VLMK MARK-UPS
3-7-13

SCHNITZER-HESSLER HOUSE

SCHNITZER-HESSLER
MAIN FLOOR DECK EXTENSION

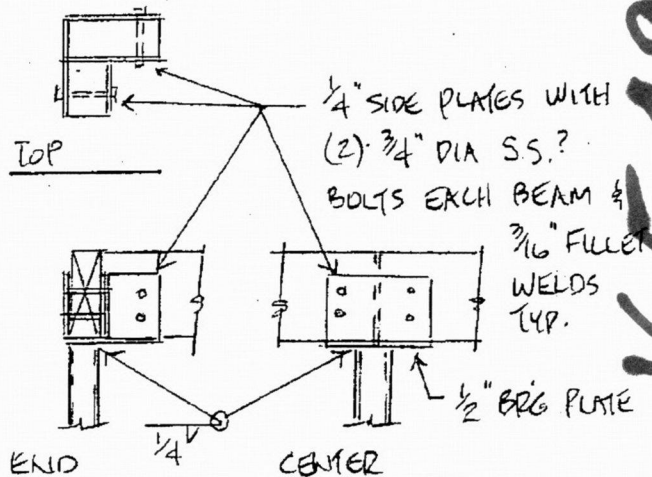
TIE DECK TO HOUSE WITH
SIMPSON 'LTI19' PER PLAN
PROVIDE SOLID 2x DIAGONAL
BLOCKING AND STRAPPING
PER PLAN (REQ'S NOTED
ON SHEET 2.2.)

END "RETURN" BEAMS TO BE
MIN P.T. HEM FIR 4x10 (OR 6x10)

2x6 DECKING (MAHOGONY OR RECYCLED
MATERIALS) OVER P.T. 2x10 JOISTS @ 16" O.C. WITH SIMPSON 'LU' OR 'LUS'

HANGERS * COATING
COMPATIBLE WITH
P.T. WOOD *

NEW BEAM PER
ENGINEER

NEW P.T. HEM FIR #1 6x10

EXISTING BEAM SHOWS ROT
REPLACE PER ENGINEER
VERIFY OR REPLACE WITH
P.T. HEM FIR #1 6x12

5 x 5 x 1/4 STEEL COLUMN
(TYPICAL OF 3)

1/2" BASE PLATE WITH
(4) 3/4" DIA x 10" EMBOS.
J-BOLTS (OR THREADED
ROD WITH PL WASHER & NUTS

24" DIA x 36" DEEP FOOTING.
(5) #4 VERTICAL WITH (3) #3
HOOP TIES IN TOP 6" AND
8" O.C. BELOW

FRONT (WEST) ELEVATION PARTIAL WEST ELEVATION

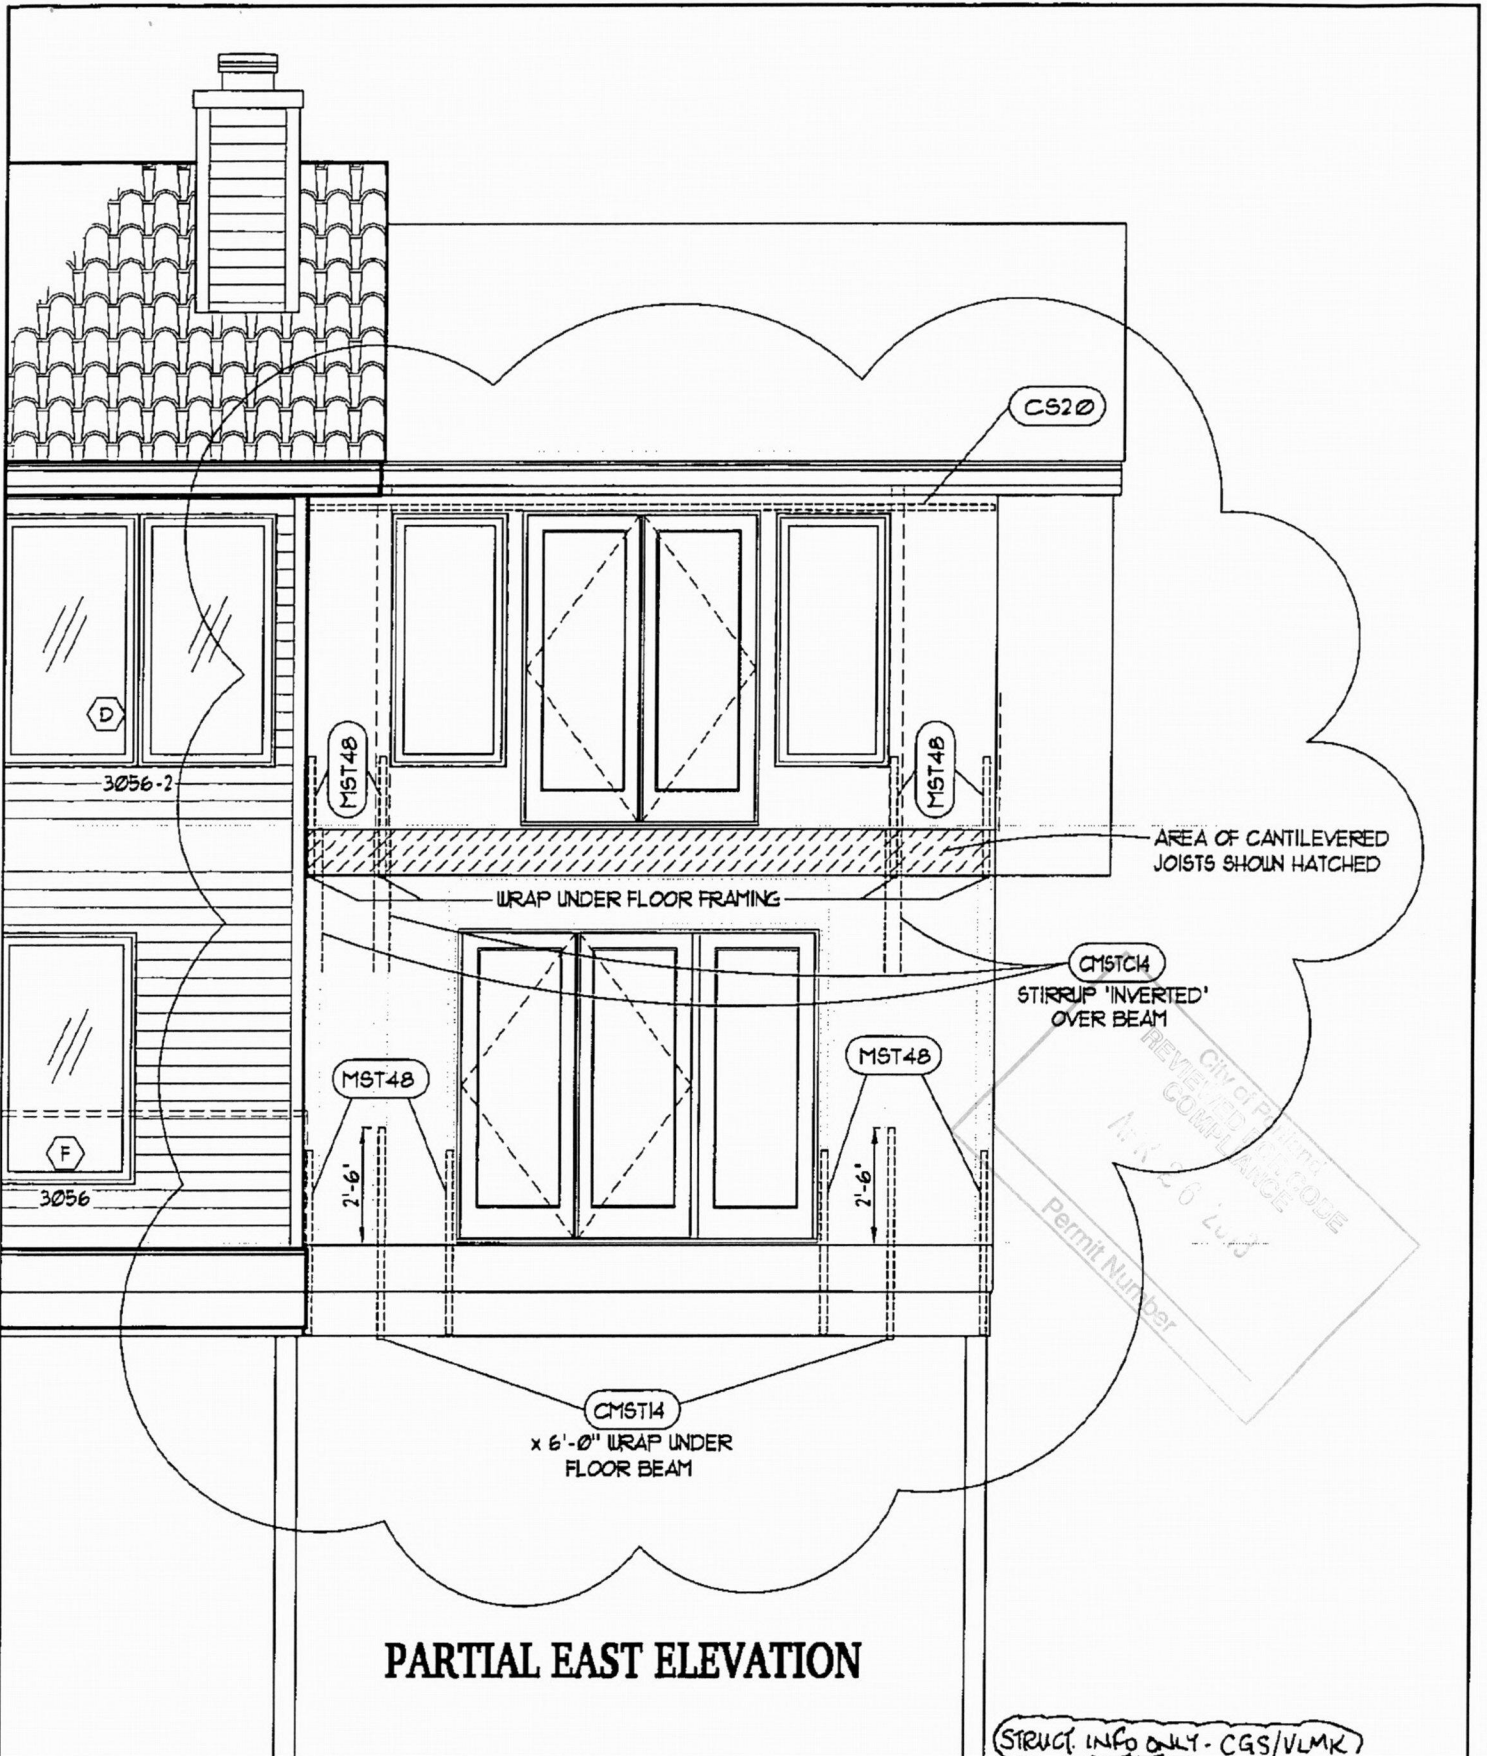
MSTC28

CMSTC16

STIRRUP 'INVERTED'
OVER BEAM OR BOTH
SIDES X 5'-0"

STIRRUP 'INVERTED'
OVER BEAM

HDU5
PER PLAN

5/8" DIA THREADED ROD
ANCHOR SET IN ADHESIVE W/
1" EMBEDMT
